Bathroom blocking - decide the marks before cutting

NTS: do not measure these pictures. Dashed items have no fixed size/position. Basis: John used the 21-page English R2 packet; page references below are to R2.

A BACK WALL - look toward tub

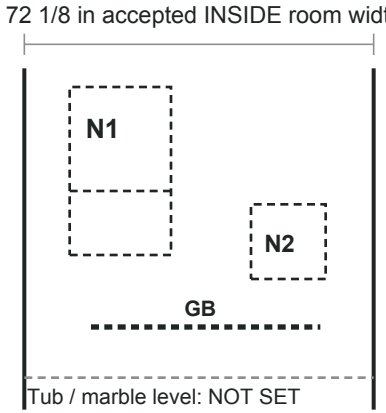
N1 + N2 (pp10-11) TISA + JOHN: agree final finished sizes, bottom/shelf heights and horizontal positions. JOHN: check studs/services; allow for board, waterproofing and tile before rough openings are cut.

GB TISA: choose bar and height. INSTALLER: use its actual mounting pattern and required blocking/fasteners. Do not copy a height from the mockup.

B CONTROLS END - face right wall

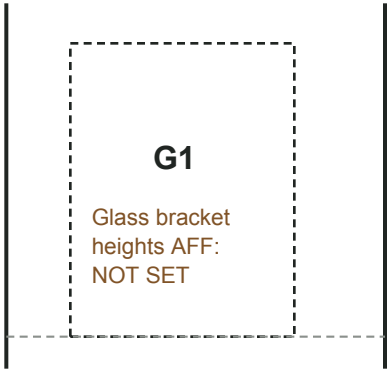
G1 Controls end. GLASS INSTALLER: identify system, wall brackets and mounting locations; provide backing/anchor requirements. JOHN: leave those locations available until confirmed.

Do not use the mockup to set glass width, height or screw locations. Protect space for valve, spout and services; their offsets are not issued here.

C TUB / MARBLE - small section

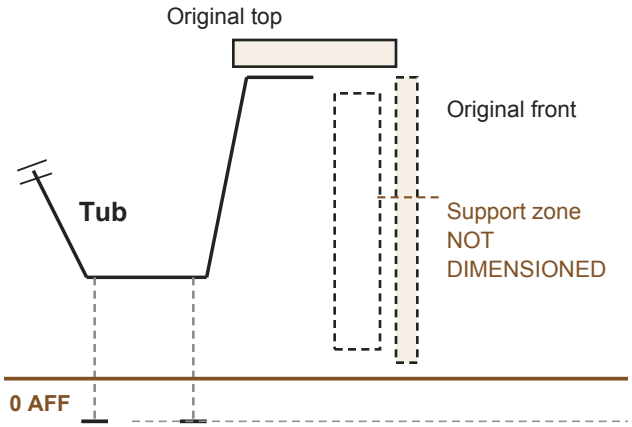
DO NOW - JOHN: dry-fit tub/stone. Measure flange top/underside FROM SUBFLOOR; stone thicknesses, front height, overlap/joint, clear stud span. AFF awaits floor build-up; room width is not a frame cut.

Tub bears on feet/base; stone needs separate support/retention. R2 underside-minus-1/8 rule is UNRESOLVED, not a cut instruction. Producer/stone installer must resolve the support detail.

TISA: confirm ledge height above marble. JOHN: measure actual finished width/depth. Height and cuts remain OPEN.
